Design Review Board Case #2017-0006
Hoffman Town Center – Blocks 4 & 5

Application	General Data	
Project Name: Hoffman Town Center Blocks 4 & 5 Location: 2410 and 2460 Mill Road Applicant: StonebridgeCarras	DRB Date:	January 18, 2018
	Site Area:	5.08 acres
	Zone:	CDD#2
	Proposed Use:	Residential, Retail
	Gross Floor Area:	1,051,048 sf
Purpose of Application:		
DRB Concept review of the Hoffman Town Center mixed-use retail and residential complex scheduled for public hearings in March 2018 (Stage 2).		
Staff Reviewers: Thomas H. Canfield, AIA tom.canfield@alexandriava.gov Robert Kerns, AICP, robert.kerns@alexandriava.gov Gary Wagner, RLA, gary.wagner@alexandriava.gov Nathan Imm, nathan.imm@alexandriava.gov Bill Cook, william.cook@alexandriava.gov		
<p>DRB ACTION, NOVEMBER 16, 2017: The applicant presented the project submission and subsequent revisions made.</p> <p>Senior Building: Architecture was shown for the first time and the board was pleased overall with the clear architectural direction of a simple grid pattern and warehouse feel. Garage treatments along the building facade and immediately west were received favorably.</p> <p>Podium: The DRB advised exploring more openness

Illustration 1: Example of Architecture Comment #1 and #2

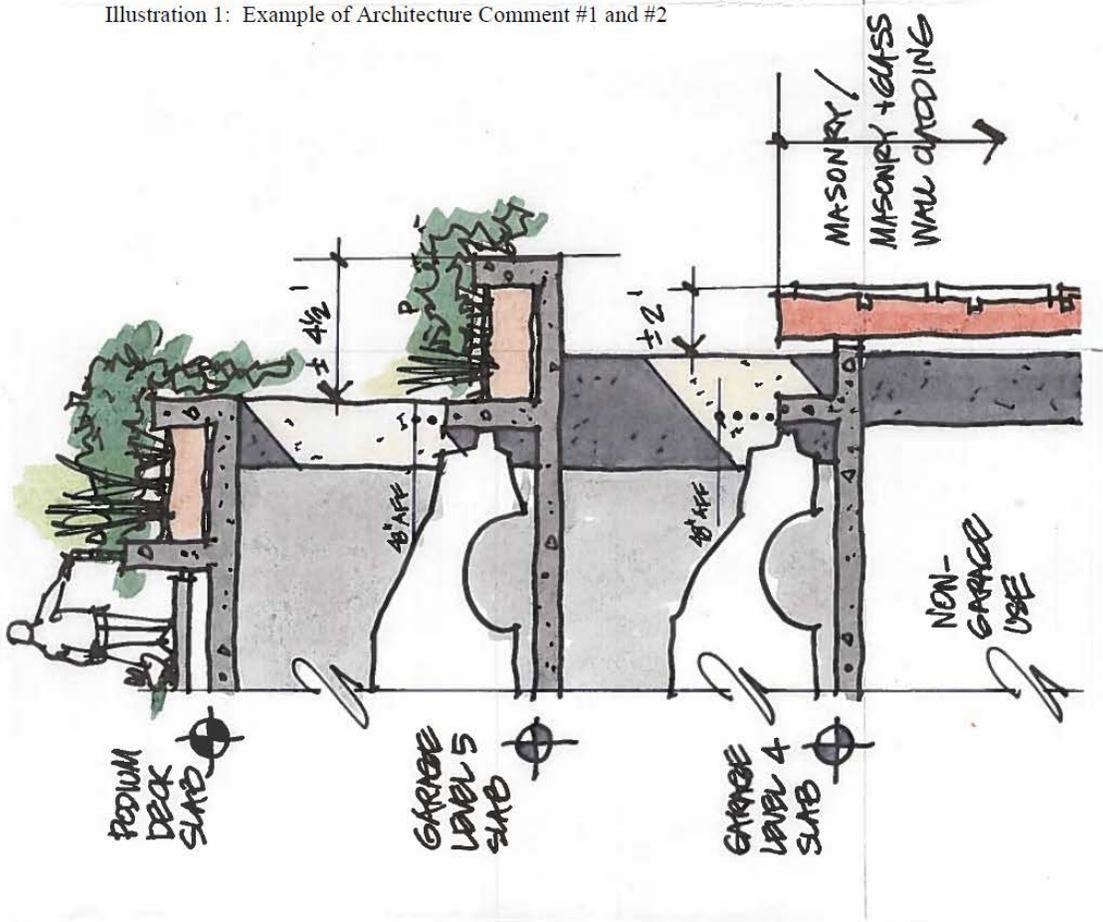
1. Garage 5th level and podium deck edge: (all sides, wherever possible) reduce perceived podium height by stripping off cladding, adding edge planter at podium deck, and pushing guardrail back, to reduce visibility of top level *and* provide a visual cue to the presence of the landscaped deck beyond. Wherever this can be achieved, it will also allow for increased air flow.

2. Garage link between Senior Living and Multifamily buildings: strip off cladding on Levels 4 and 5, as well as podium deck edge, using planter treatment as above, to create a stronger break between buildings. This may also be possible for much of the length of the blank façade currently shown along Mill and Stovall (both are “C: streets) in conjunction with 7) below, allowing reduction in visual bulk and improved garage ventilation.

Comment #2

Comment #1

Illustration 2: Example of Architecture Comment #1 and #2 and Landscape Comment #1

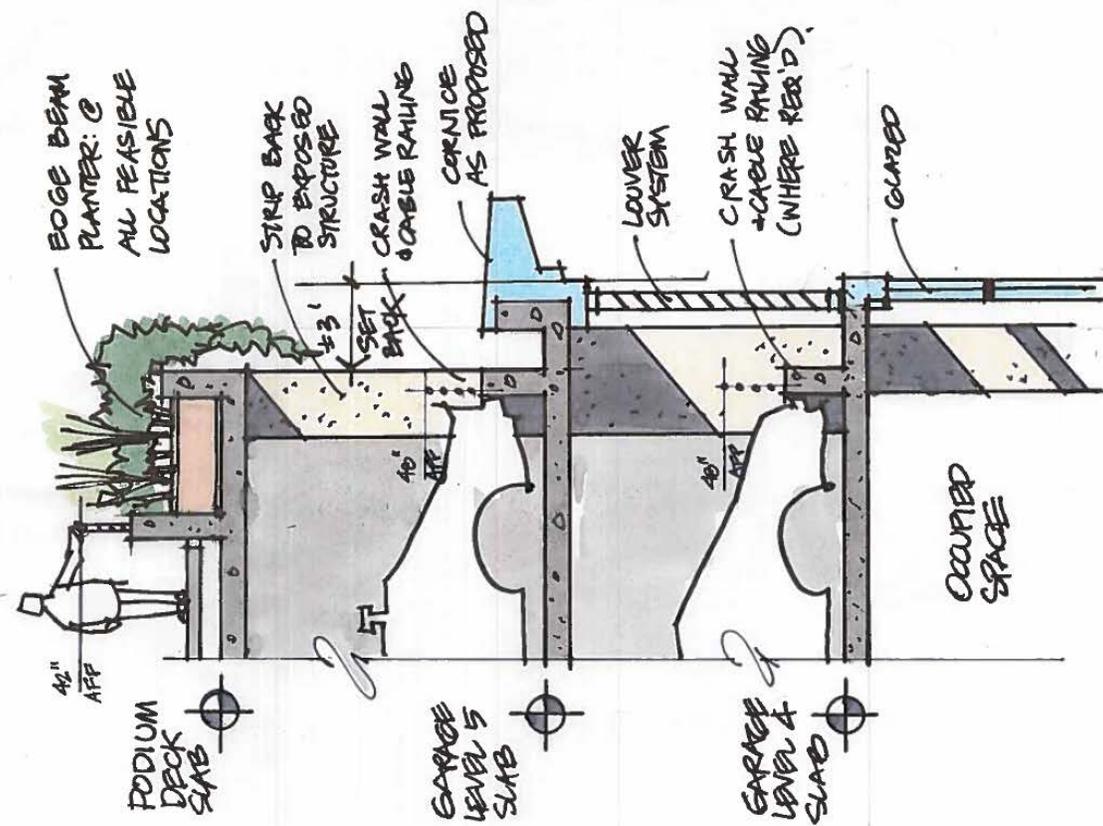
1. Develop a 24/7 pedestrian connection between the east and west portions of the landscaped podium deck; whether this connection is internal (through the Multifamily Building) or external (ex. along the north edge of the podium along Mill Road) it is important to allow all residents free access to the varied amenities such as dog parks and playground areas, distinct from the more private amenities proposed for each rooftop.

24/7 CONNECTION BETWEEN EAST + WEST POOLUM DECKS

Illustration 3: Example of Architecture Comment #1 - #4, #6 - #8

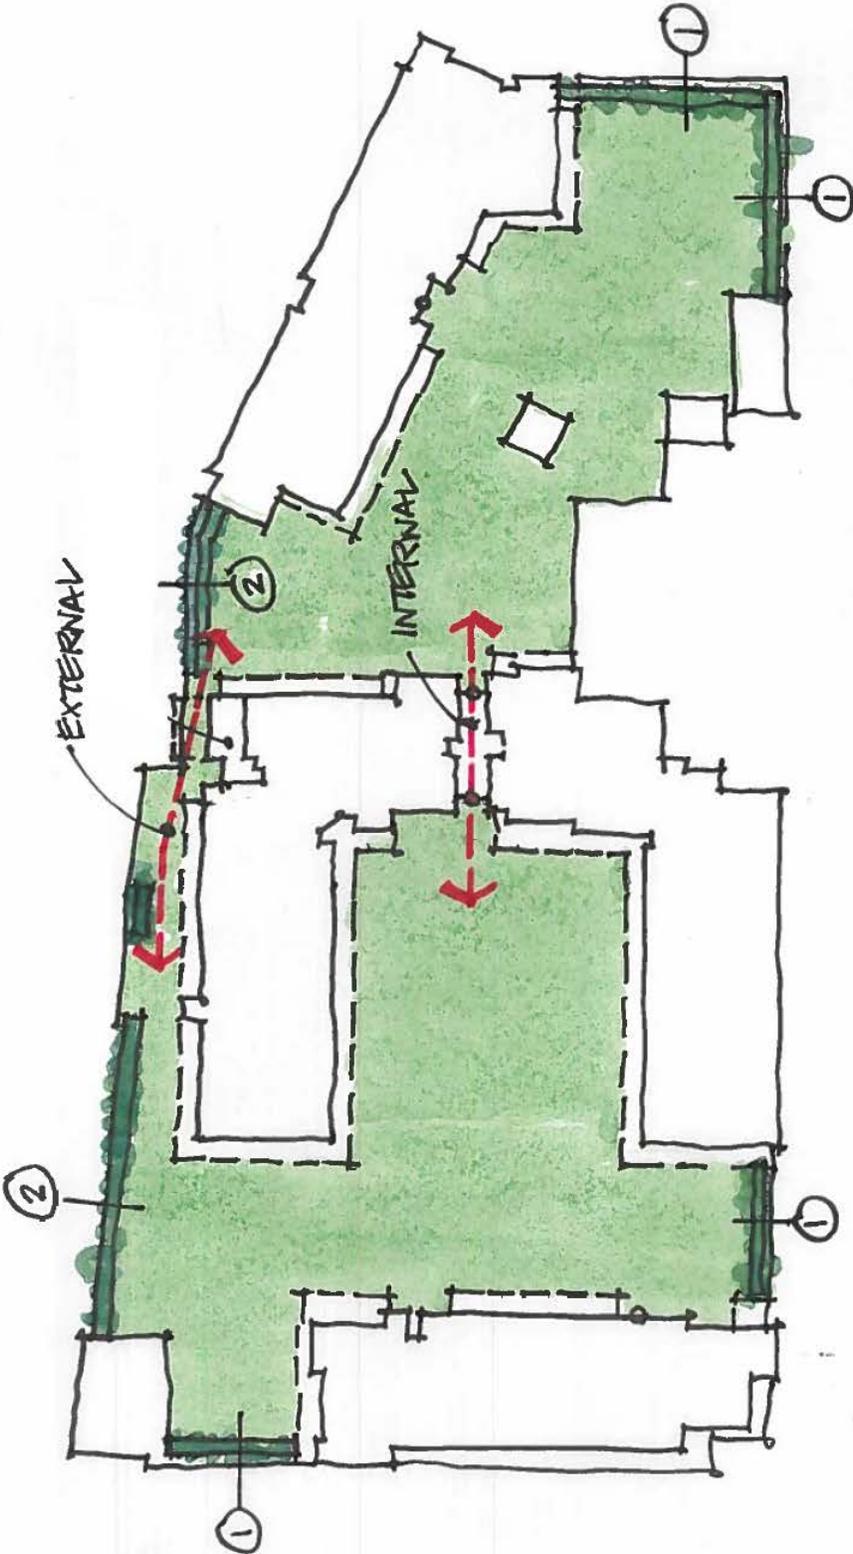
3. Condo Building: The alteration of the penthouse forms has created a “box-top” that distracts from the overall design of the buildings. As such, the north accent penthouse forms need additional refinement. Staff recommends that the Applicant study previous iterations and study connecting the two forms to create a stronger expression.

4. Multi-Family Building: stronger integration/expression of penthouse forms, through the use color and plane changes; delete slab-edge expression, which looks dated.

6. Simplify expression of screening wall along Mill and Stovall: the checkerboard pattern competes with tower architecture: this component of the complex should be a strong, simple background element, and needs to be coordinated with MEP ventilation requirements; also study strategies to reduce its physical bulk, as in 1) and 2) above.

7. In conjunction with 2) above, study the elimination of the Condominium service corridor currently shown on Parking Level 5, in favor of integration with the required service corridor on Level 1, which can connect directly to the Condominium vertical core

8. Senior Living Building: façade rhythmic organization should be simplified/clarified; scale/color of glazing subdivisions needs refinement – gridded glazing does not currently read strongly.
